#2026-117
7501 S. Route 31 –
Quik Trip Gas Station Conceptual PUD
Project Review for Planning and Zoning Commission

Date:	November 18, 2026
Request:	Conceptual Planned Unit Development review for a new 6,445 SF gas station with Variations.
Location:	7501 South Route 31
Acreage:	Approximately 3.2 acres
Zoning:	O Office Planned Unit Development
Surrounding Properties:	North: B-2 PUD General Commercial PUD South: M Manufacturing East: (Across route 31) B-2 PUD General Commercial PUD West: O Office
Staff Contact:	Elizabeth Maxwell (815.356.3738)

SHEET TITLE:
SITE PLAN (PRELIM)

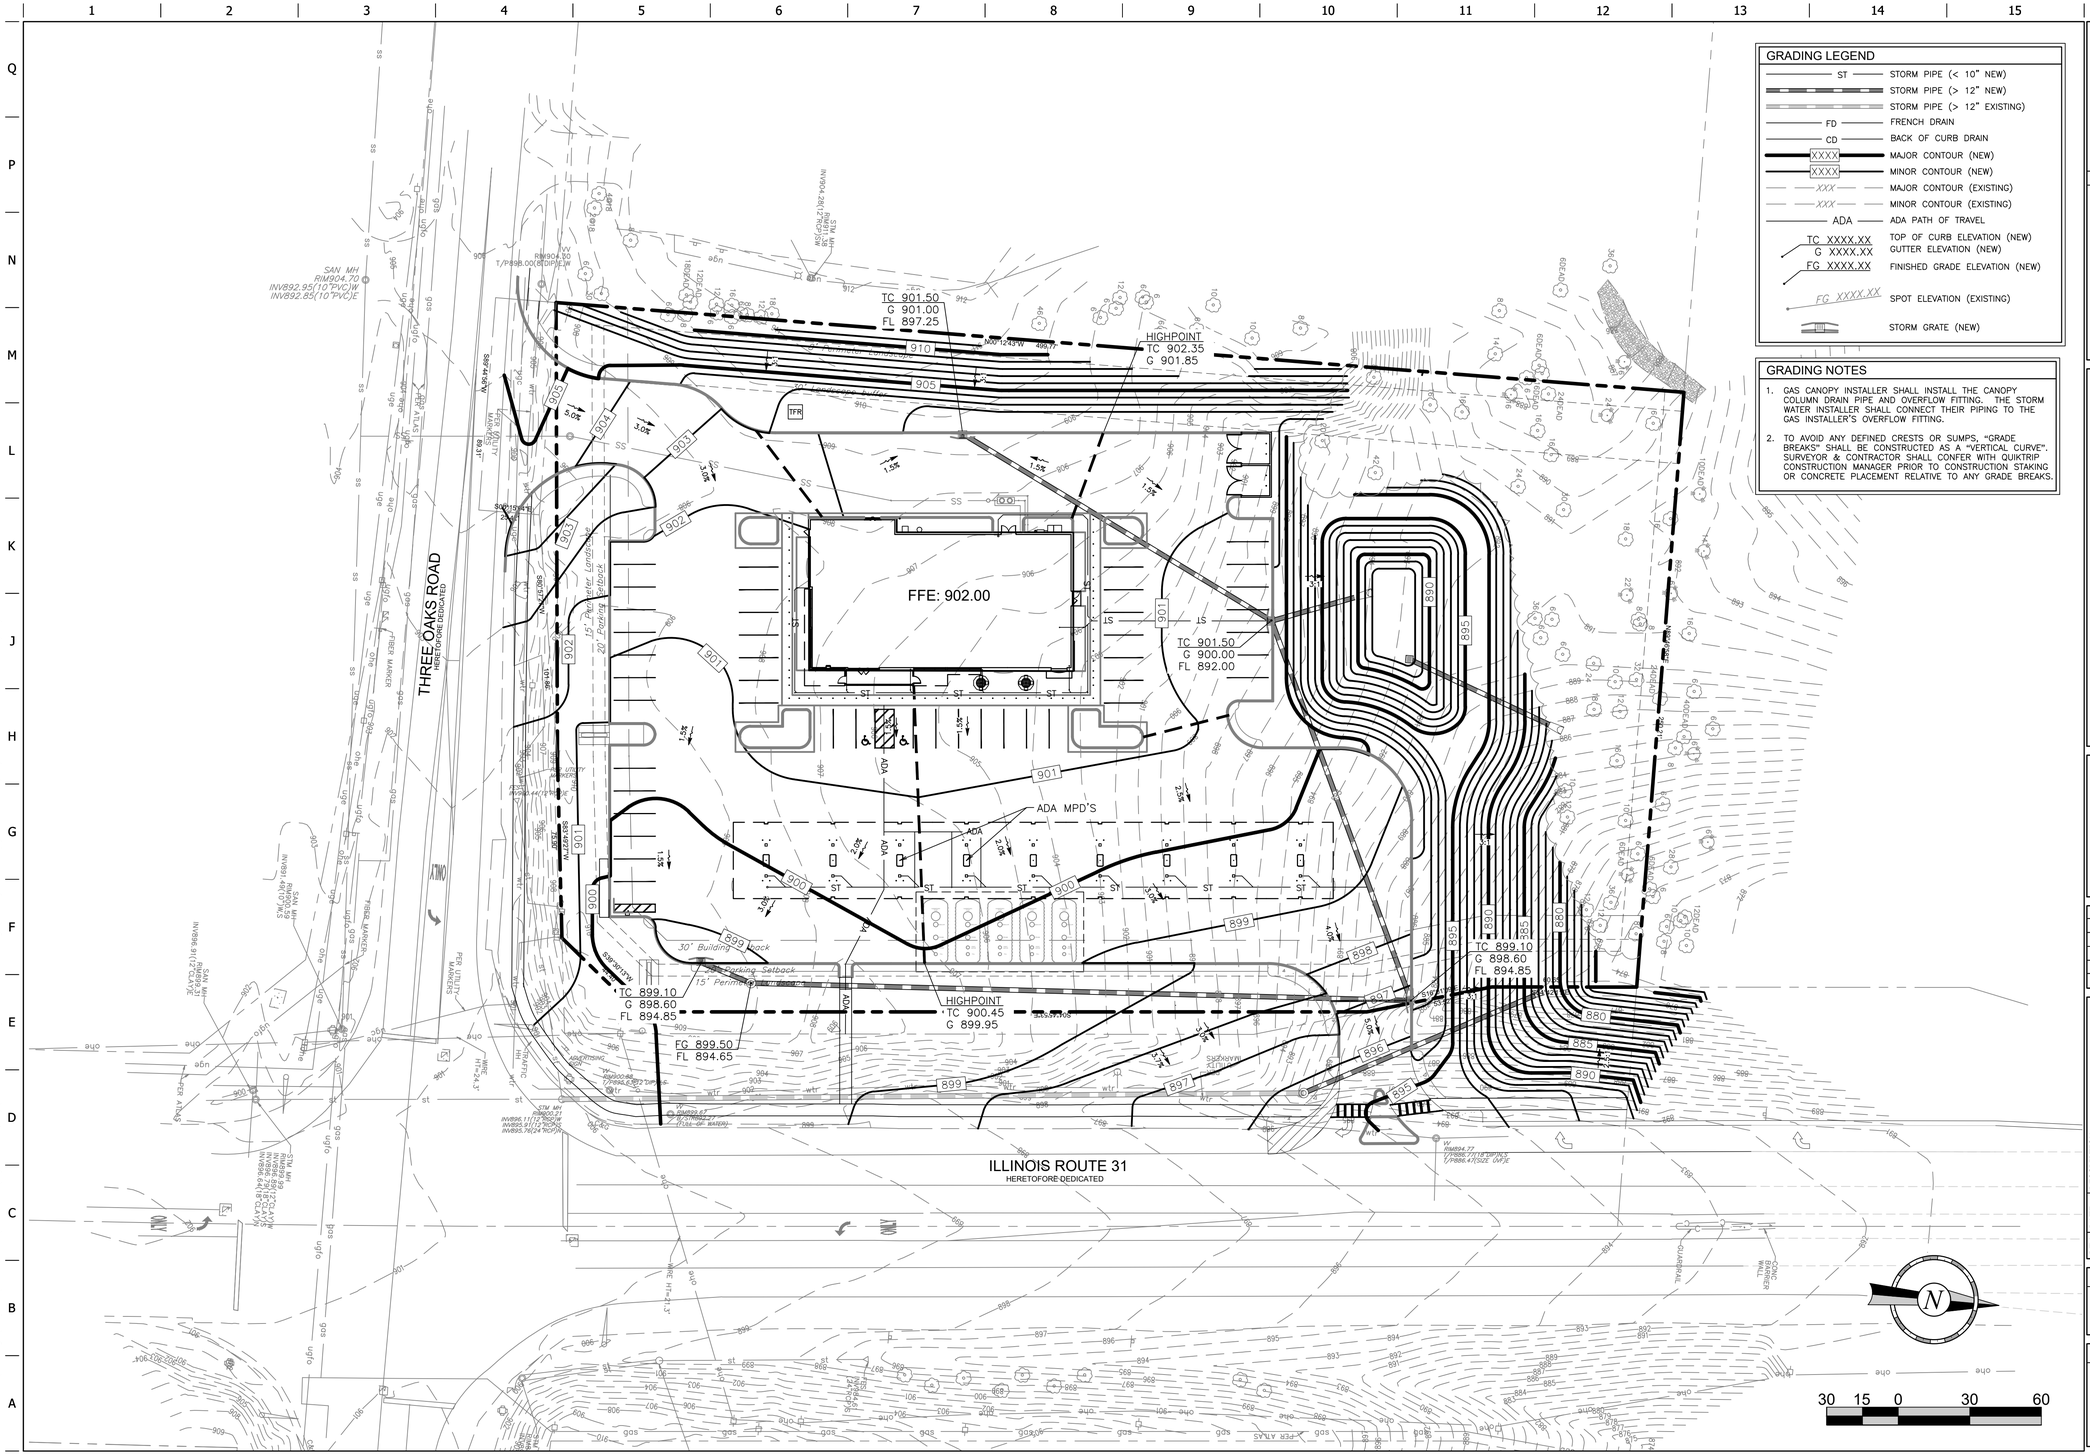
- Two access points are provided into the site. A right-in/right-out access from Route 31, as well as a full access from Three Oaks Road. The traffic study will be sent to IDOT for review and approval of access onto the State Route.
- There is full circulation all the way around the building. Staff has noted a concern of extremely wide drive aisles throughout the site that creates excessive hard-surface coverage. Standard drive-aisles are 24 feet in width, Quik Trip is showing 35 feet between parking areas, that increased around the gas pump areas. **QuikTrip has responded that based on larger vehicles, vehicles with trailers, and visitors unfamiliar with the layout the wider aisles allowing for easier turning movements worked well for the store.**

- This use requires 18 parking spaces plus parking for gas pumps. There are 45 parking spaces plus parking at gas pumps. Per UDO Section 4-200 Parking states that for parking areas less than 200 total spaces anything over 125% of the required parking would be permeable surface. This helps reduce the stormwater impact and discourages overparked sites. For this site, any parking over 23 spaces would need to be in a permeable surface to reduce coverage.
- **A new staff concern that has been noted is the tree removal due to the detention. Staff has suggested doubling the gas pumps to shorten the canopy length and revise the stormwater management area and outflow to avoid the eastern side of the site as much as possible to save mature trees including Oak and Shagbark Hickory.**

- Foundation Base Landscape. Portions along the front and rear of the building have no foundation base landscape.
- Setback. The required setback between commercial and office requires a 30-foot landscape buffer from noise, lights, and traffic. A very small landscape buffer is shown for a portion of the site. The majority of the western property line would not provide any required landscape buffer between this site and the office building next door.
- Hard-Surface Coverage. The project has reduced the max impervious coverage to 54%, which does not require a variation.

Front Elevation

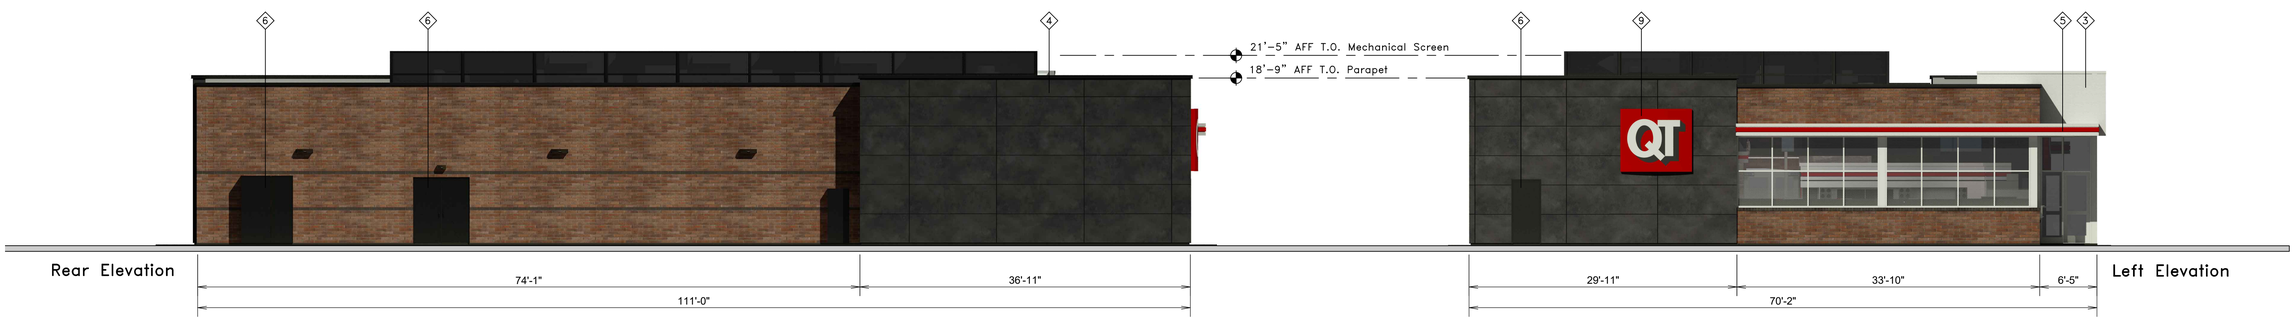
- The main components of the building are brick and stone panels. The dark black sections, colored Ossido Nero, are stone panels. The main section of the building brick is Bronzestone structural brick with trim brick colored Midnight.
- The front entryway is an aluminum storefront.
- The red illuminated banding on the building will be considered signage.
